From: Christian Araguas
Sent: Wednesday, November 12, 2008 3:18 PM
To: jtdavis@southernco.com
Cc: wasparkm@southernco.com; agaughtm@southernco.com; crpierce@southernco.com
Subject: Advanced Safety Evaluation Report on the VEGP ESP and LWA Part 3b/3
Attachments: Vogtle ESP Advanced SER Chapter 2.5.2 - 2.5.6.pdf

2.5.2 Vibratory Ground Motion

Figure 2.5.2-19 - Results of the staff's site response calculations for high-frequency rock motions for the 10^{-4} hazard level. The applicant's mean results are shown for comparison.

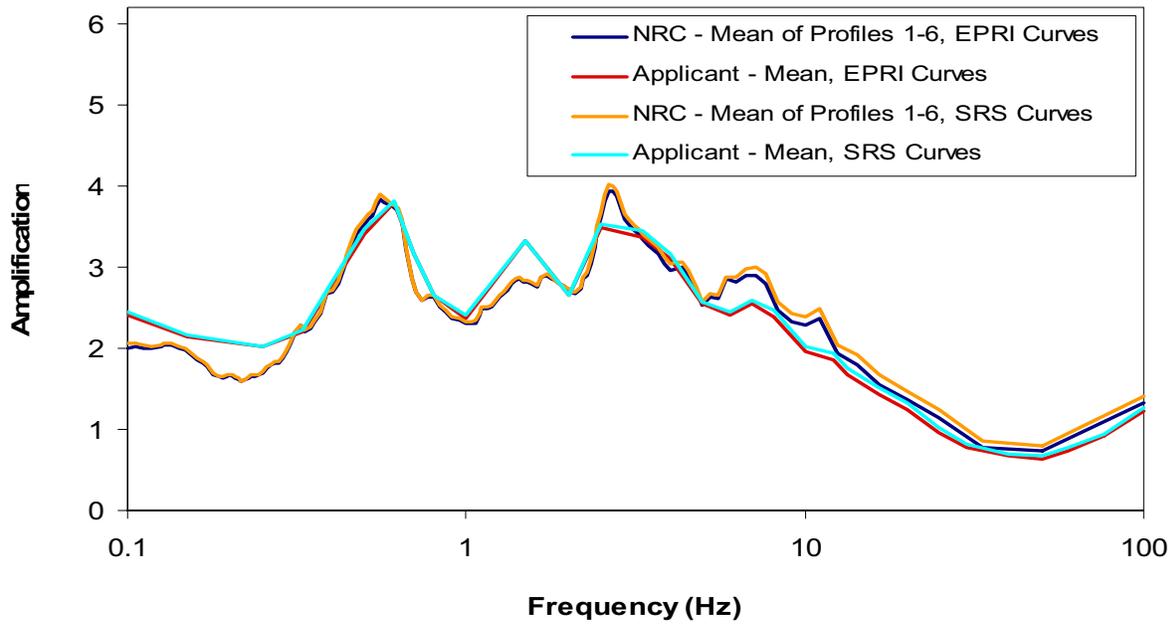
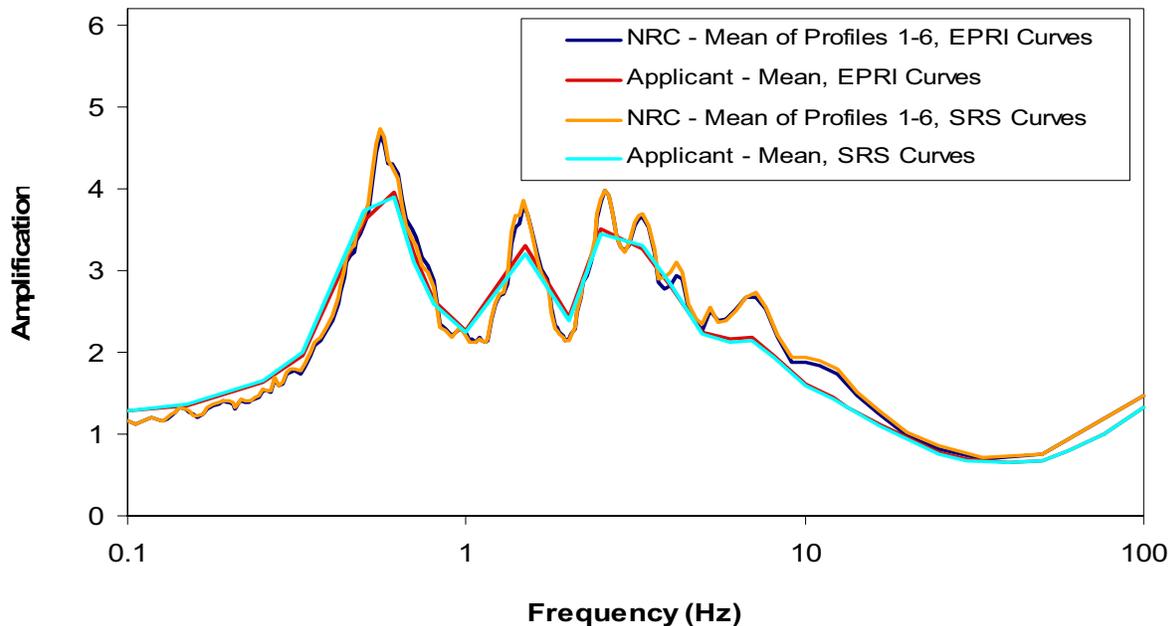
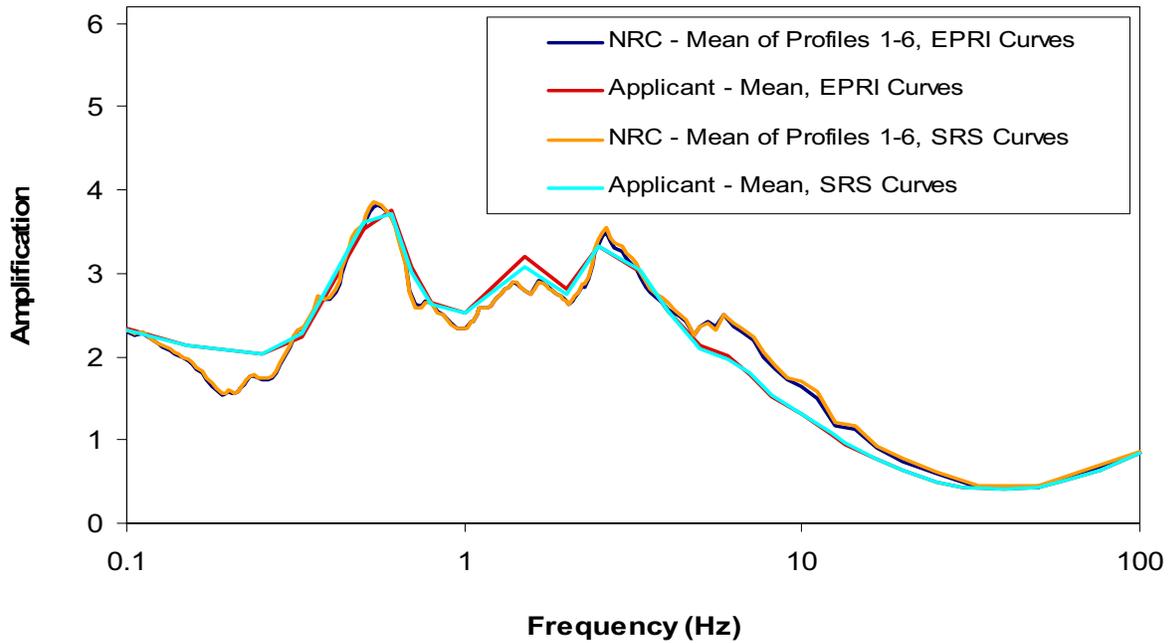
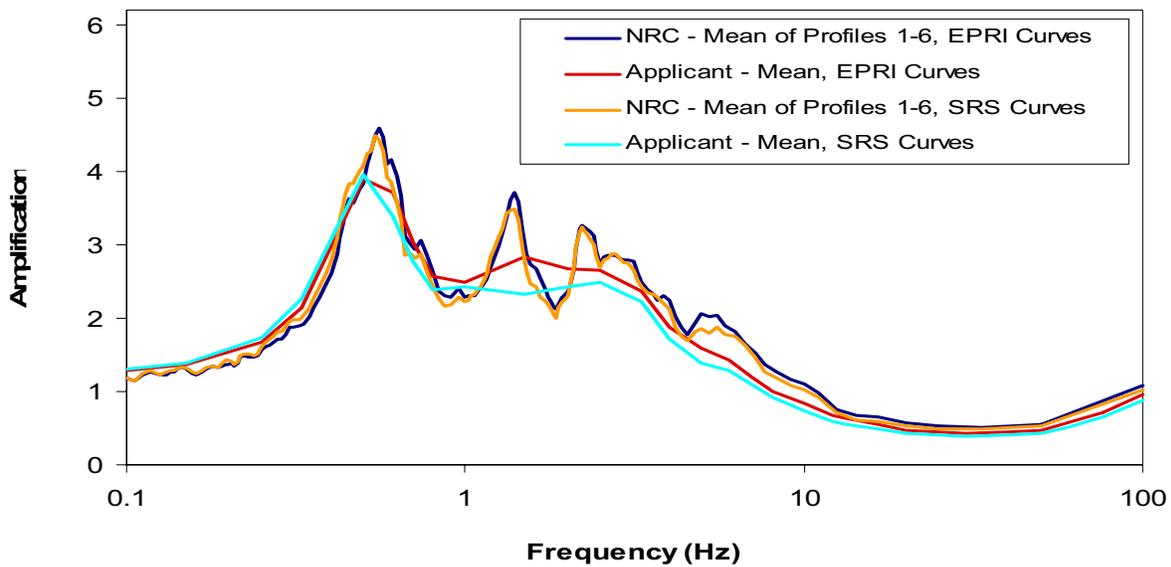
SER Figures 2.5.2-19 to 2.5.2-22 show the mean AFs resulting from the staff's confirmatory site response calculations. Each figure plots the mean results of the six alternative subsurface profiles for both the EPRI and SRS shear modulus and damping curves. SER Figures 2.5.2-19 and 2.5.2-20 show the results corresponding to the 10^{-4} hazard levels for the respective high- and low-frequency input motions, while SER Figures 2.5.2-21 and 2.5.2-22 plot the results corresponding to the 10^{-5} hazard levels for the respective high- and low-frequency input motions. SER Figures 2.5.2-18 to 2.5.2-22 also show the applicant's mean AFs for comparison. The applicant's results are similar overall. For each case, the amplification peaks are very similar, and in all cases, the peaks occur at approximately 0.6 Hz. The differences between the results are likely due to the greater variability that the applicant incorporated into its model through the use of randomized profiles and material properties, as well as the use of multiple time histories. This variability is illustrated in SER Figure 2.5.2-23 (reproduced from SSAR Figure 2.5.2-37). As a result of its analysis, the staff was able to confirm the applicant's overall site response results.

Figure 2.5.2-25. Plots of the horizontal and vertical GMRS (based on the information provided in SSAR Table 2.5.2-22b and SSAR Section 2.5.2.7.1.3).

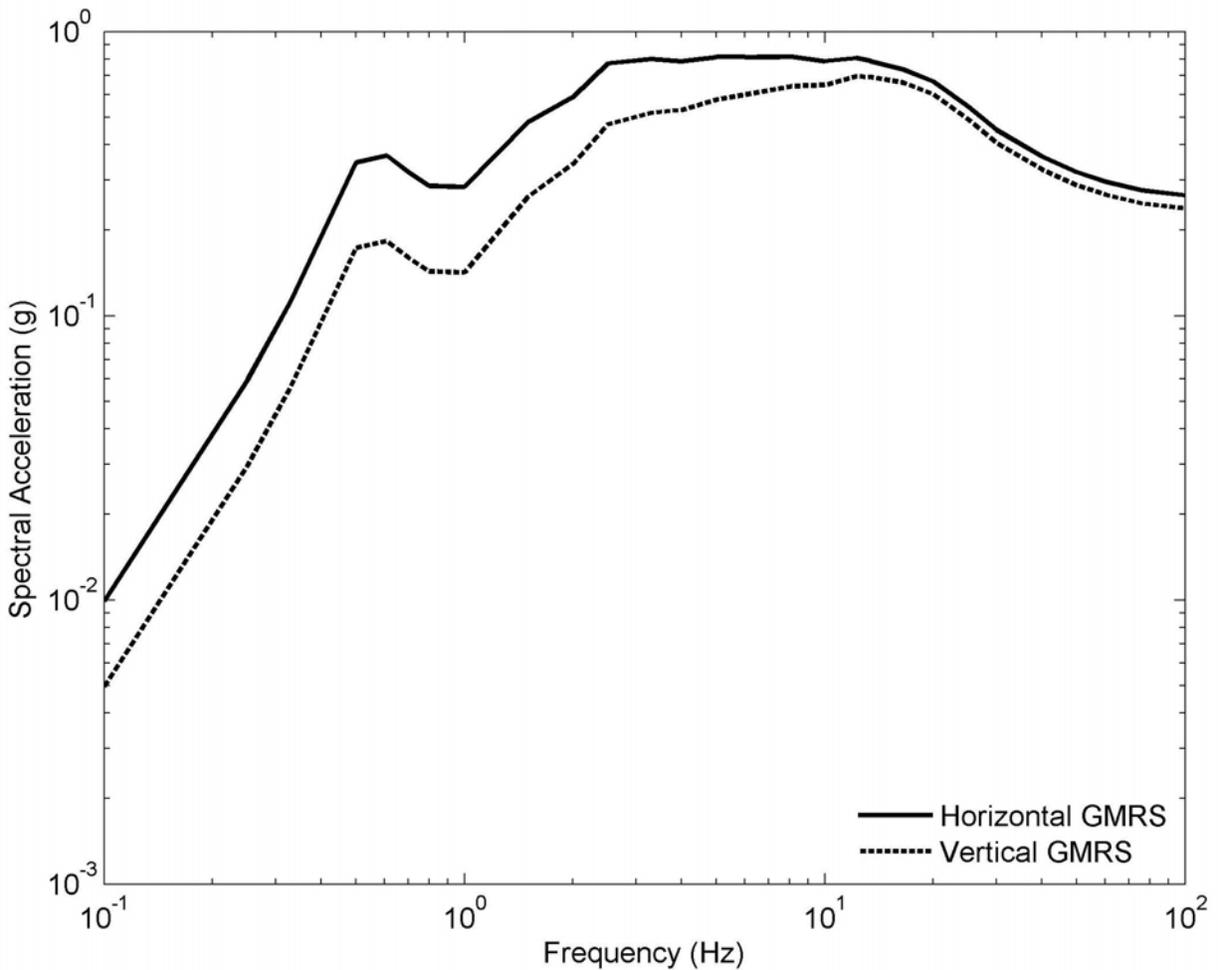
Based on its review of SSAR Section 2.5.2.6, the staff thus concludes that, overall, the applicant's horizontal and vertical GMRS, which are shown in SSAR Figure 2.5.2-21, are acceptable. The applicant followed the general guidance provided in RG 1.208 to develop both the horizontal and vertical GMRS for the Vogtle site. In SSAR Table 1-1, the applicant identified

the GMRS as an ESP site characteristic⁹. For the reasons set forth above, the staff agrees with the applicant's GMRS as a site characteristic, which appears as SER figure 2.5.2-25 and in Appendix A of the SER.
